ADDENDUM TO APPLICATION
BLOCK 136, LOT 8 (30 GRANT AVENUE)
MARKOV APPLICATION
BOROUGH OF RUMSON

Denial Memorandum

Applicant: June Markov
Address: 30 Grant Avenue Block Lot Zone
Rumson, NJ 07760 136 8 R-5

Add 1-½ stories and a new two-story rear addition on an existing, nonconforming, one story dwelling, in the R-5 zone, on a slightly oversized, conforming, and interior lot.

SITE PLAN
project no 24017.00
sheet no. SP-1.00

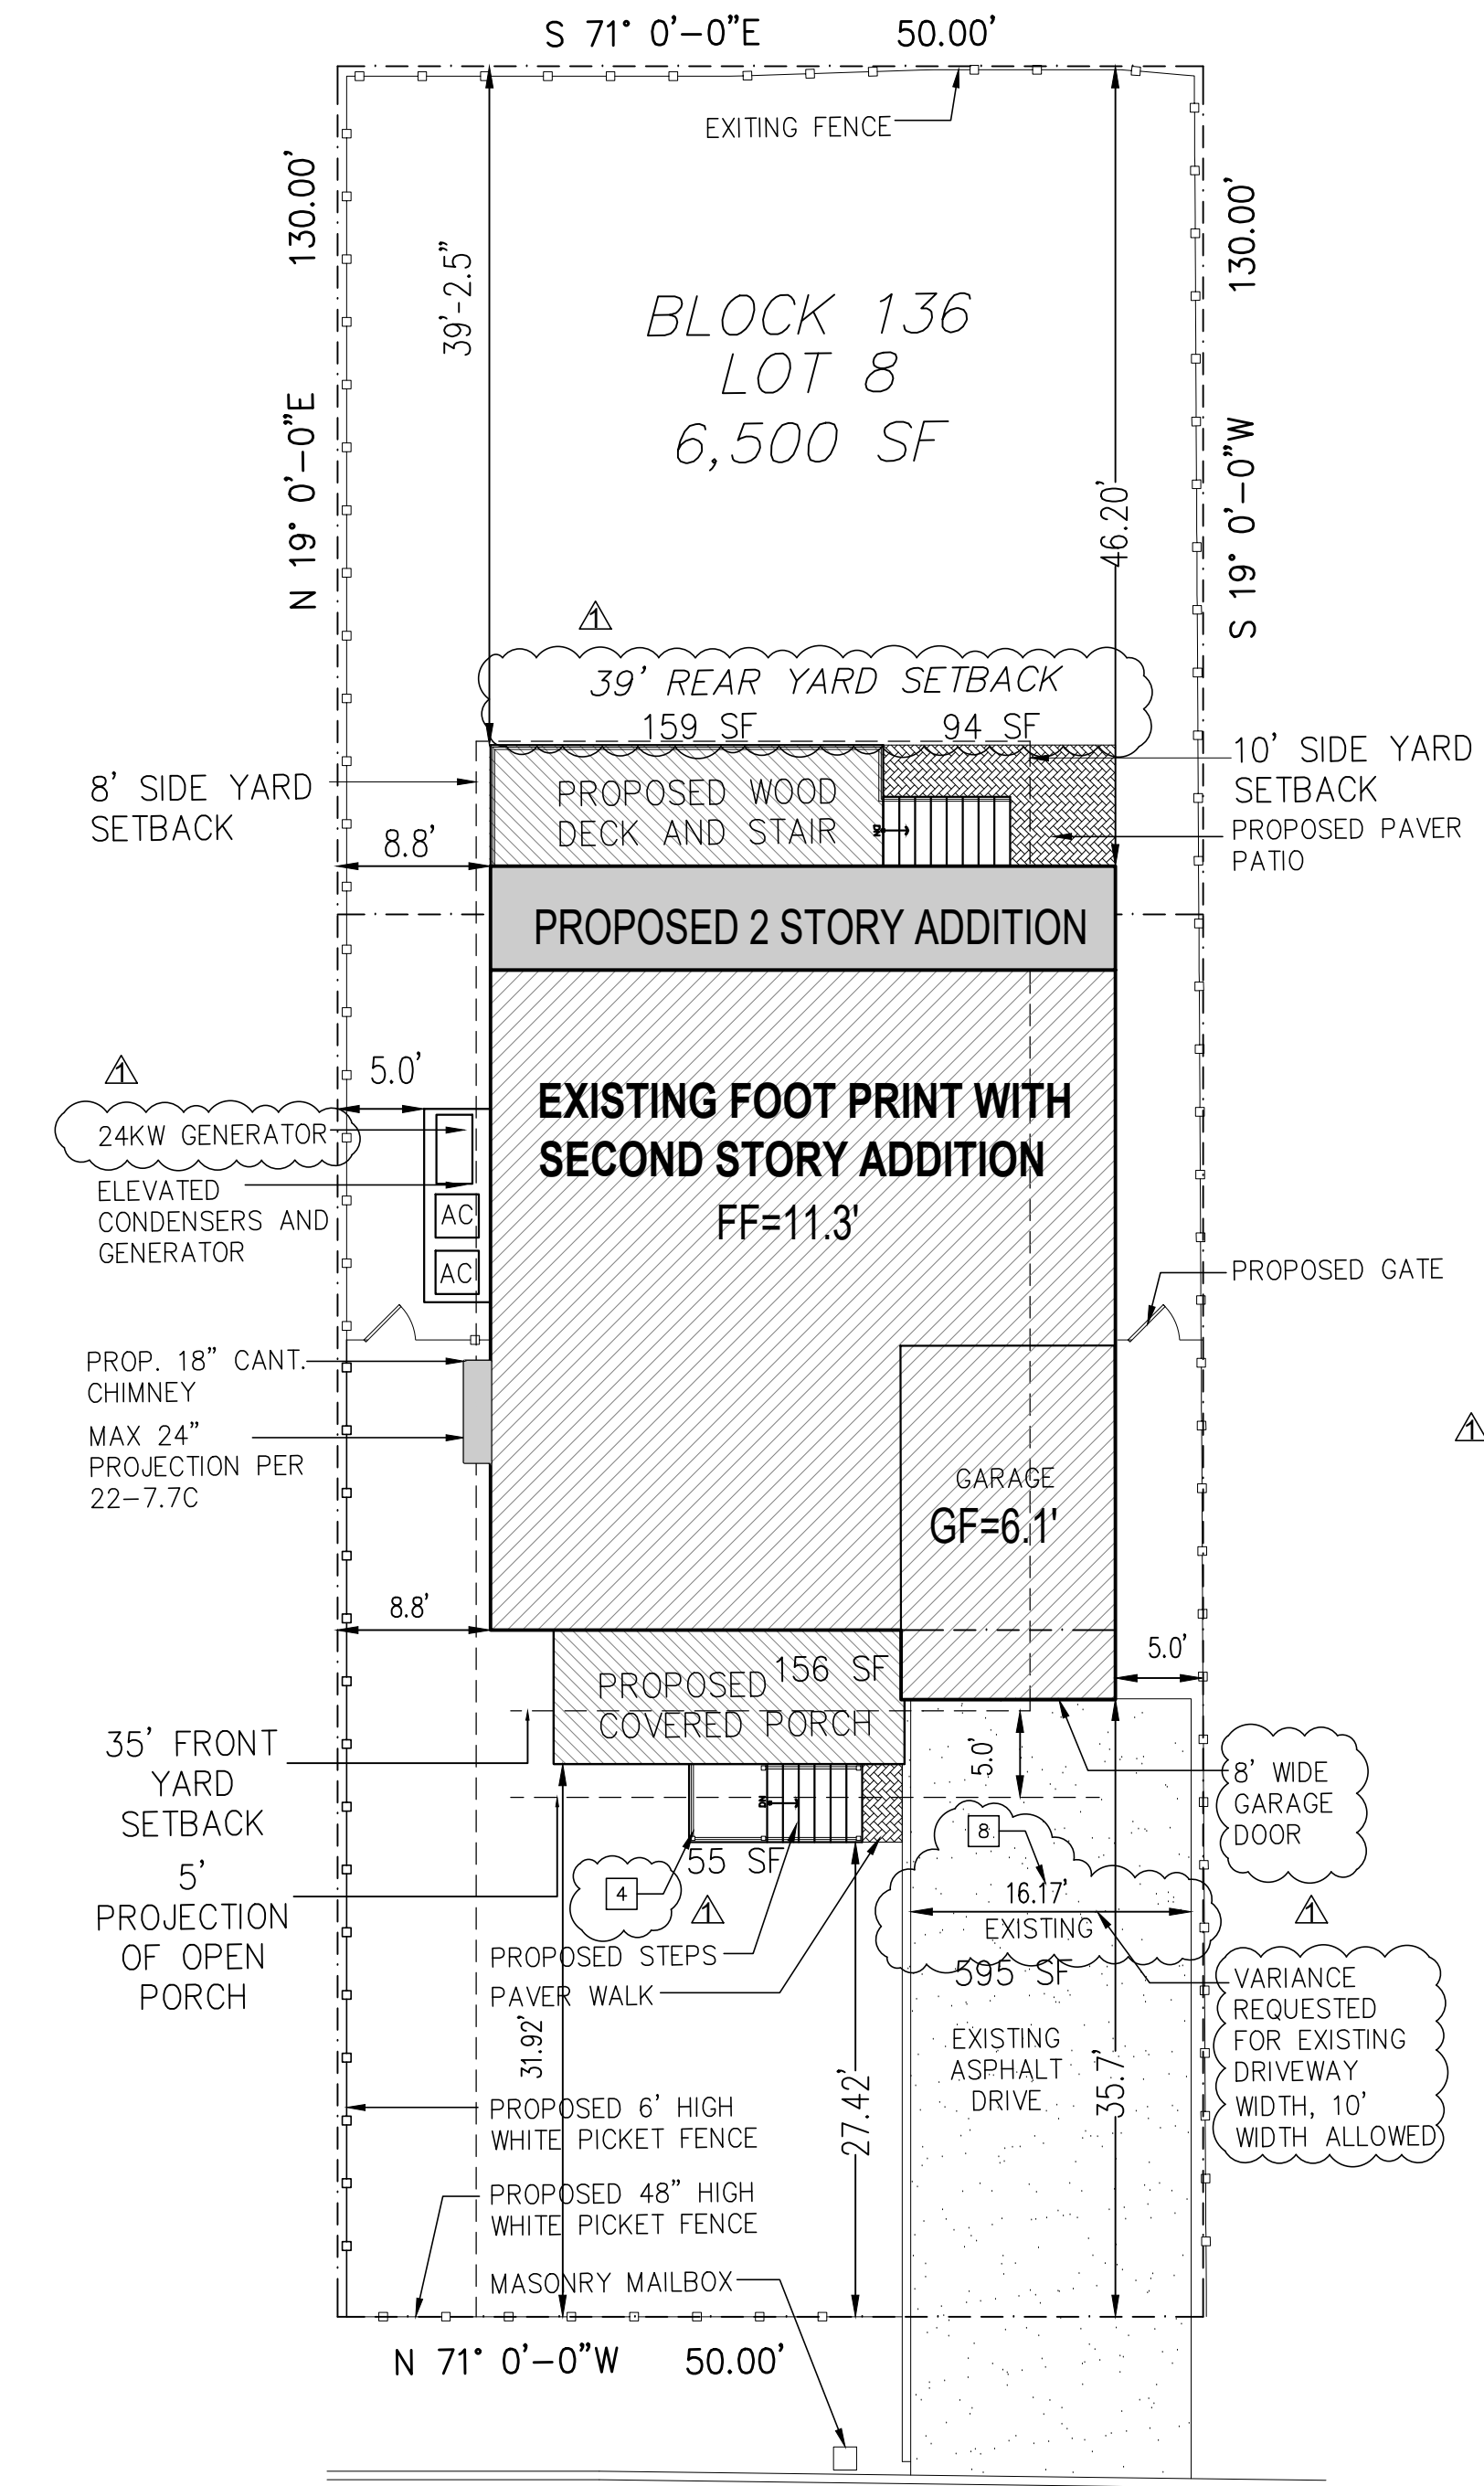
10. Zoning Chart Information requiring correction:
 - To comply with half-story status, please provide the proposed area that is greater than 5' above the second floor. This cannot be greater than 60% of the floor area below it. (Half story status is <60% of the floor below it, habitable attic is <1/3 of the floor below it).

- Note 2: the maximum permitted floor area 'cap' refers to properties in the R-5 Residential Zone that result in floor area calculations greater than 3,500 SF (properties greater than 10,000 SF).

- Note 5: as shown, the proposed rear yard setback is 39'-2.5". Please correct in Zoning Chart
